SANITARY SURVEY FORM - INVENTORY

PWSID 0400260
Date of survey: 3/14 & 19/2018

SYSTEM NAME Hopi Cultural Center

SURVEYOR NAME – **Dan L. Fraser, P.E. & JanDee May of Sleeping Giant Environmental Consultants, LLP**

Schematic of Installation:

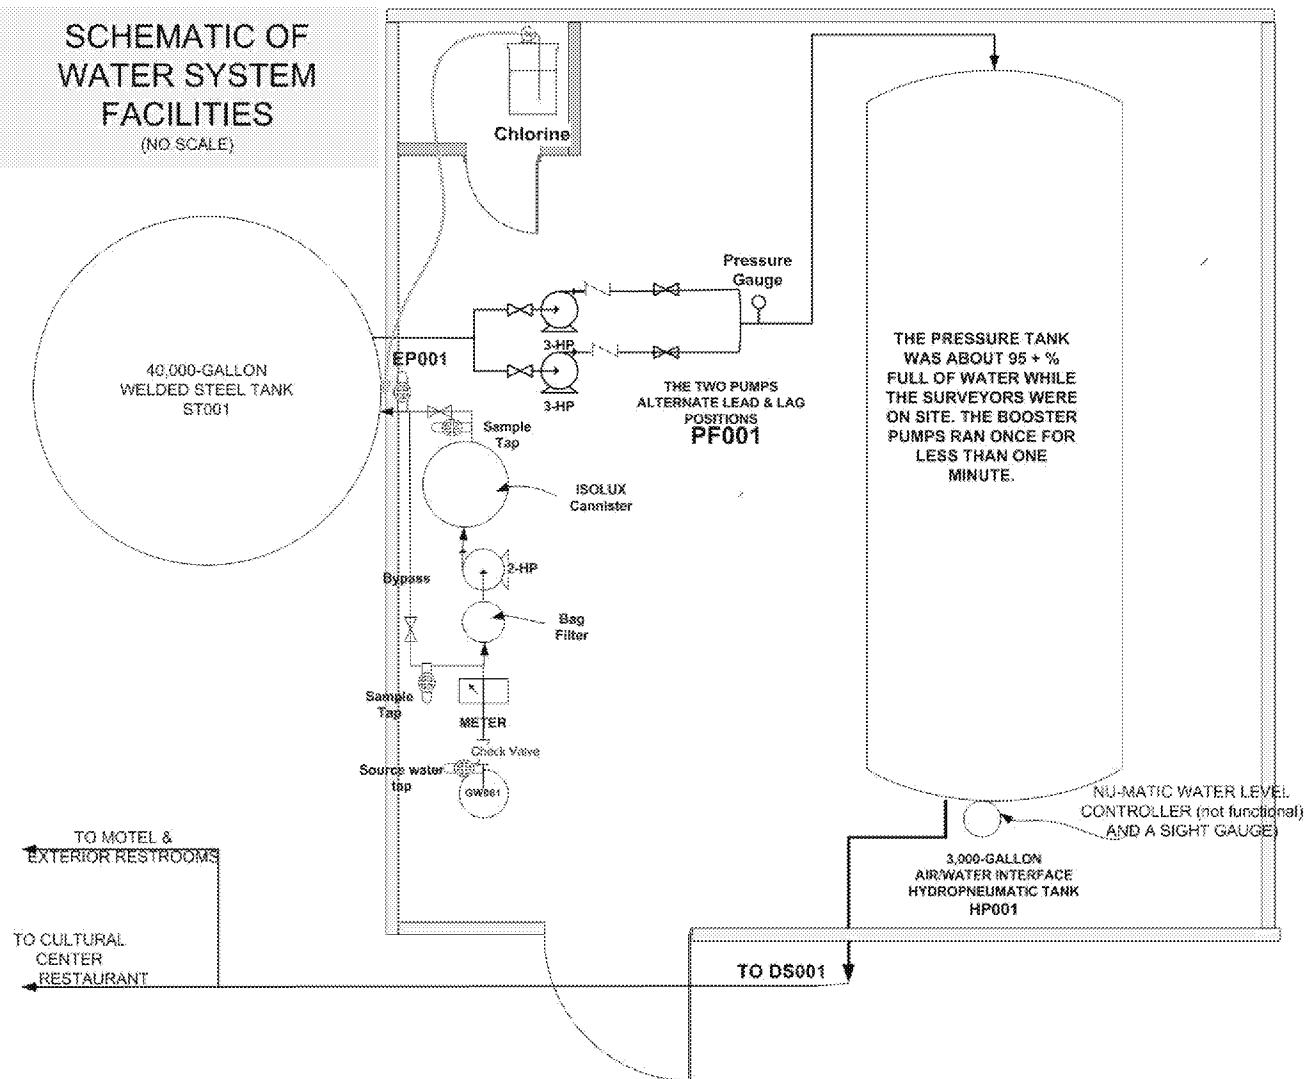
Comments: The pressure tank should be taken out of service and inspected to make sure it does not present a serious safety risk to the operators. The tank is nearly waterlogged.

It should be noted that the chlorine is injected post-arsenic treatment. SGEC recommends injection as early as possible pre-arsenic treatment to oxidize dissolved arsenic in the well water.

ISOLUX arsenic removal system.

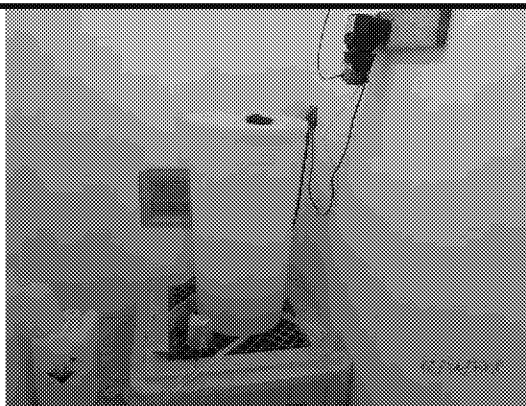
Comments: SGEC recommends that the chlorine injection point be moved to a point ahead of the arsenic removal system to oxidize the dissolved arsenic.

Schematic of TP001
(no scale)

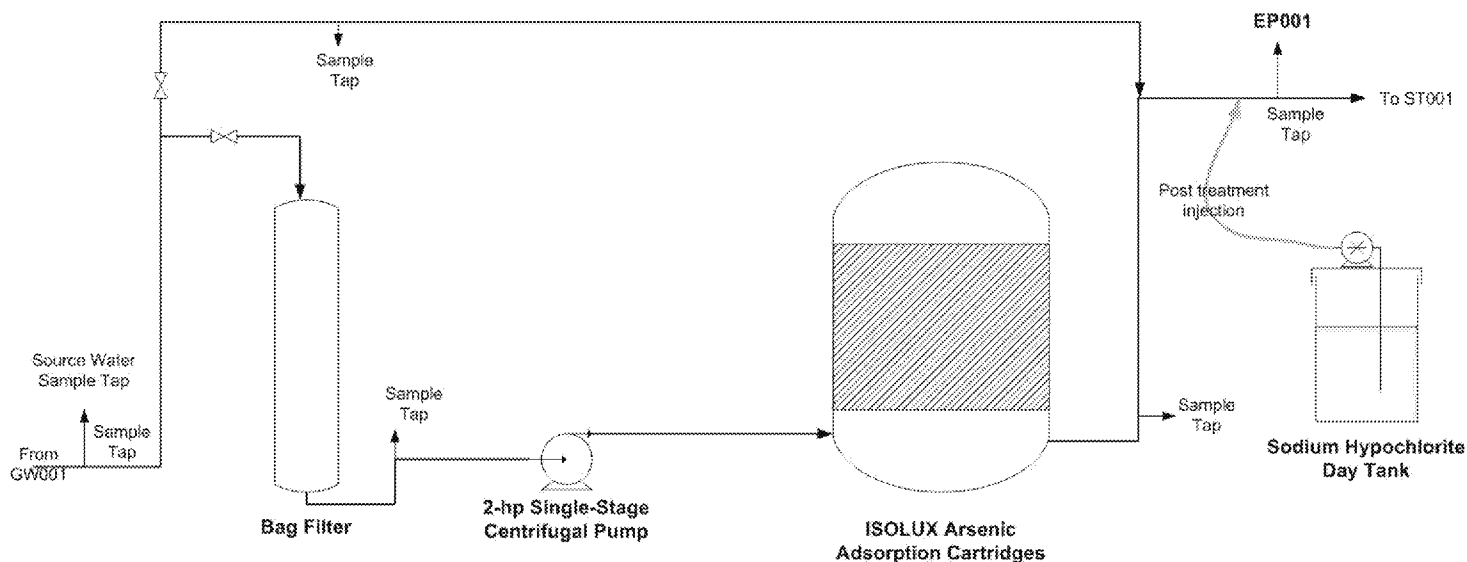
As the treatment plant is currently configured, the water is chlorinated after it passes through the bag filter, ISOLUX unit and bypass line. This does not make sense to SGEC as pre-chlorination may be necessary to ensure oxidation of the dissolved arsenic in this deep well. If pre-chlorination is initiated, there will not be very much contact time to ensure oxidation occurs before it passes through the adsorptive media.

The water is currently bypassing the bag filter and ISOLUX units because of air problems in the well water. Therefore, the PWS is almost certain to be violating the MCL for arsenic (SGEC does not have monitoring reports to support this assumption).

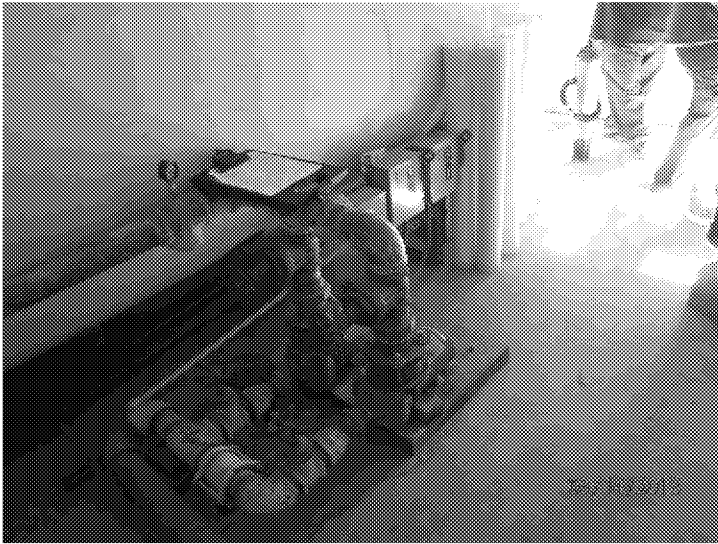
WSF ID HP001 Location, Description It is a 1970 vintage welded steel 3,000-gallon hydropneumatic tank. It likely has never been inspected and rehabbed and may be dangerous. At the time of the last sanitary survey, facilities management hoped to replace it with a skid-mounted duplex VFD pumping facility. That hasn't happened due to funding.

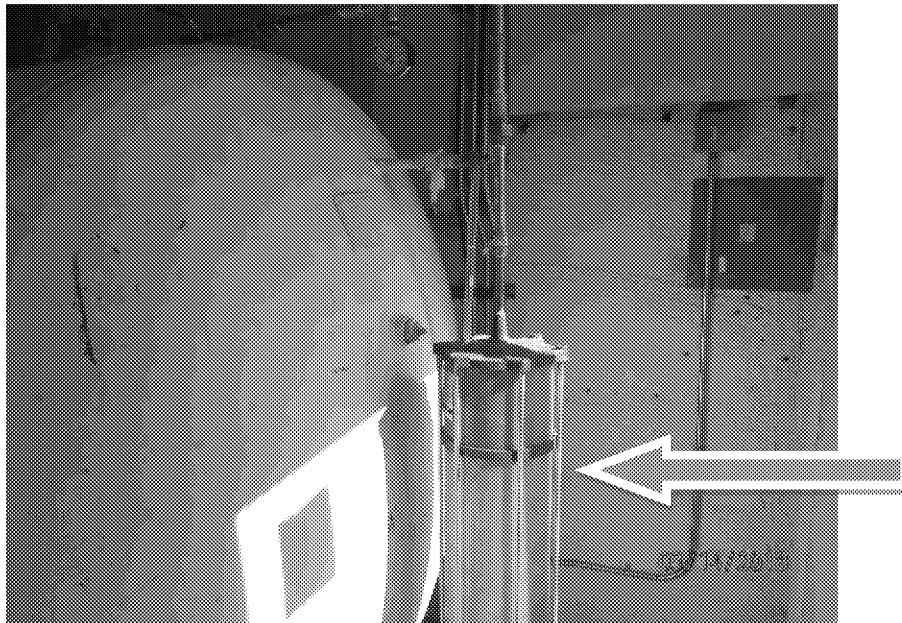
Comments: The Nu-Matic controller is not working and air has to be introduced with a compressor.

The Nu-Matic unit is designed to keep the appropriate amount of air in the tank. It is not working so the operator must periodically bring in an air compressor to provide supplementary air. It currently needs air to be added.
